Highland Ave., Long Island
(Irene Bryant, owner)-1

Subject: Building permit for demolition of present ell and construction of new ell at the rear of cottage of Irene Bryant on Highland Avenue, Long Island (Assessors Lot No. 103-C-3)

Subject: Application for building permit to cover
addition and alterations at cottage of Irene
Bryant on Highland Avenue, Long Island

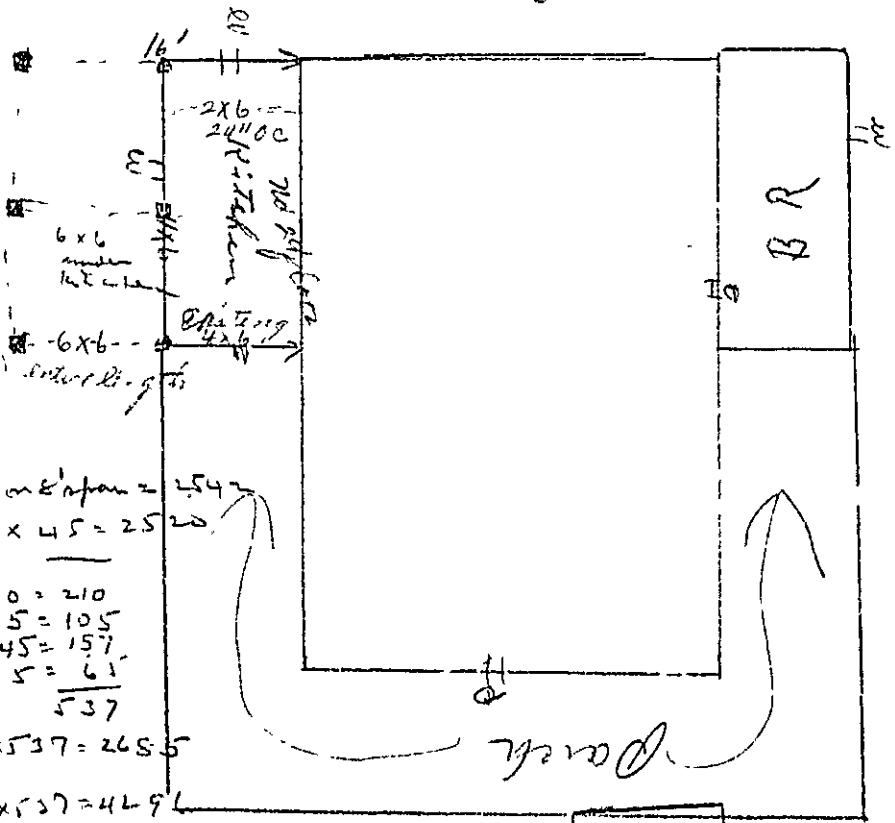
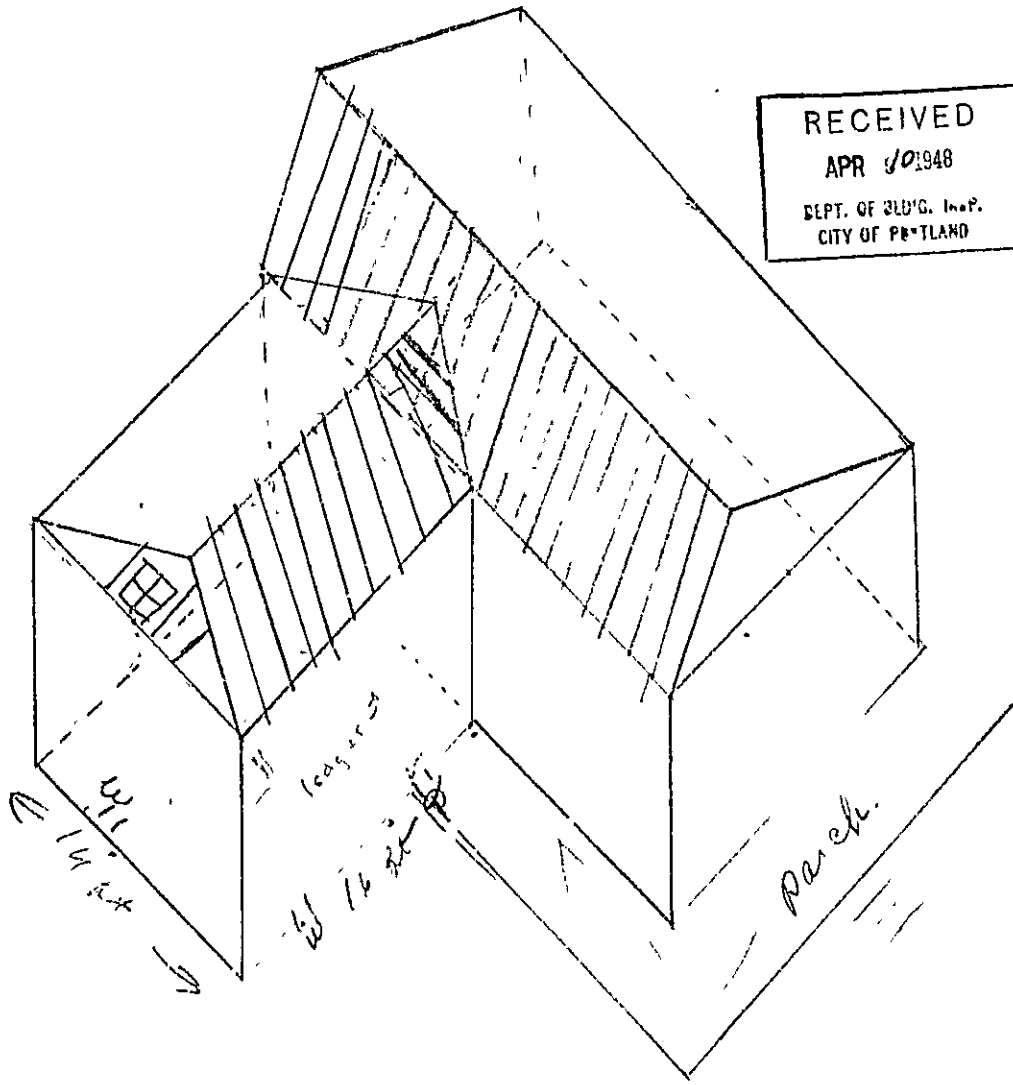
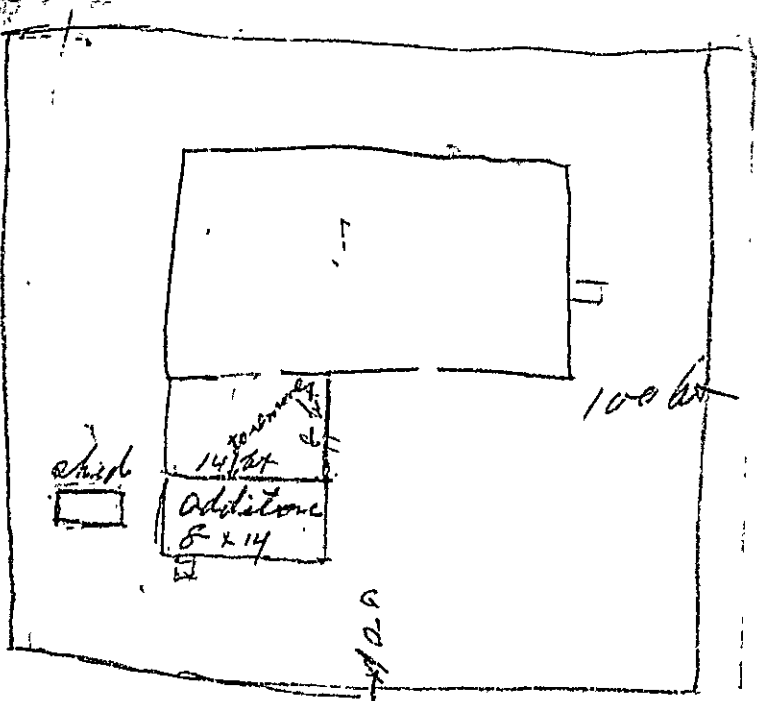
I have tried to puzzle out just what you have in mind as to the framing and supporting of this addition and the new roof over the kitchen and issue the building permit with a conditional letter, but I find that there are too many questions to which I do not have the answer for me to issue the permit on this basis, because the Building Law actually requires that I shall be certain of compliance with the Building Code from information furnished by the applicant before the permit is issued.

It will be necessary for you to furnish a foundation and framing plan showing the location proposed for the piers under the addition, the kind of foundation under the present kitchen section (if this is also piers or posts, the location of them should be shown and the size of the aisle and center girder, if any), the framing of the present floor of the kitchen and whether or not there is a second floor over the kitchen now together with the framing and direction of joists and size and spacing of them to make up the new roof over the kitchen section; also the framing proposed for the floor of the addition and for the roof of the addition.

I presume the long dimension of the addition is to be 14' as indicated on the sketch, instead of the 12' indicated on the application. While you show the span of the second floor joists of addition as 14', indicating that the joists will run through that dimension of the addition, you have indicated the span of the 2nd rafters as 7' and to have a pitch of 7" to the foot seems to indicate a ridge running the 7-foot way of the addition and perhaps extending clear through over the present kitchen section to make an entirely new roof covering both kitchen section and addition.

You show the height of the plate as 13' above the grade and the highest point of the roof as to be 18' above the grade, which seems to indicate that the plate would be some distance above the second floor level, but you have not indicated anything by way of a girt or lodge board, nor have you indicated any collar beams for the roof.

You have indicated that what appears to be the rear exterior wall of the kitchen section is to be removed between the existing section and the addition, but it is not clear whether or not this is a bearing wall or whether or not second floor joists or roof joists will put any bearing over this point where the partition is removed.

You can see from this letter that we are trying to interpret the application but are quite largely in the dark as to the details which you proposed. You will clear this entire matter up much more quickly so that we can issue the permit if you will file here a clear sketch showing all of these matters in question so that we can check against Building Code requirements for strength. While we wish to help you and everyone who is trying to build, it is not possible for us to go over all of the details of such a job with the applicant in person. Even if that could be done, you have no way of conveying to the inspector in the field what verbal conclusions had been reached.

1. The present ell, 8' x 14', containing the kitchen is to be removed and a new 1½-story ell about 14' wide by 16' deep constructed. The new addition is to have a pitch roof (about 7" vertical to each foot horizontal) with the ridge running the depth of the addition (the 16-foot way), and consequently forming two valleys where the new roof joins the existing roof of the main cottage.

2. Concrete piers are to be used for foundation, no less than 9" square at the finished surface of the ground and no less than 10" square at the bottom, to extend to a flat bearing on ledge or at least 4' below the finished surface of the ground at the pier, whichever depth is encountered, and piers shall extend no less than 6" above the finished surface of the ground for the bearing of the sill, sills to be anchored to the piers by means of metal dowels cast into the concrete or equivalent, and suitable provision made to close the space under the ell between underside of the sills and the ground so as to avoid frost action on the superstructure.

3. It is understood the enlarged kitchen is to occupy the entire first story and a bedroom the second floor of the ell without any interior partitions in either room. The first floor joists are to run across the ell the 14-foot way and are to be supported under their centers by a wooden girder, making the span of the joists 7', the second floor joists are to run clear across the ell with a span of 14' and the roof rafters are to run in the same direction to meet at the ridge.

4. To bear the loads distributed in such fashion, a foundation pier will be needed under each exterior corner of the addition, two piers equally spaced under each side of the addition (thus making the 6x6 sill on spans of about 5') and piers where the side walls of the addition join the main cottage unless suitable supports can be made upon the present foundations of the main cottage. Another pier will be needed under the center of the rear end sill, making the sill on a span of 7' and this pier will also act to support the outer end of the center girder (6x6). Another pier will be needed under the center of the 6x6 center girder, making it on a span of 8', and another pier where the center girder joins the main cottage framing unless the present cottage foundations are in shape to be utilized for that purpose.

5. The corner posts are required to be either solid 4x6 or the equivalent of 3-2x4's to make a single built-up member, and are to go down to a bearing upon the 6x6 sills. The studs in exterior walls are required to be no less than 2x4, of course, and 16" from center to center since a ledger board is to be used at second floor level. The studs are required also to extend down to a bearing on the top of the 6x6 sill.

6. The ledger board is required to be no less than 1" x 6" (dressed sizes allowed), and required to be let into the studs the full thickness of the ledger board and to be nailed solidly to each stud. The plate at the tops of the walls is required to be no less than doubled 2x4, and since the plate will be some distance above the second floor level, it will be necessary to use suitable collar beams across from rafter to rafter to keep the addition from spreading at the eaves.

7. The second floor joists will require no less than 1x3 cross-bridging at about the center of the spans. These joists will rest on the ledger board and of course wherever possible will be spiked to the studs of outside walls.

8. I understand that there is no inside finish proposed of any kind, but if it should be decided to put wallboard or any other closing material on walls or ceiling, it is necessary that you give notice of readiness for closing-in and receive our green tag after inspection before any of the work is covered from view. If a ceiling is provided for the kitchen, it will be necessary to provide fasteners between the studs at the bottom edge of the ledger board as well as at the second floor level between the studs.
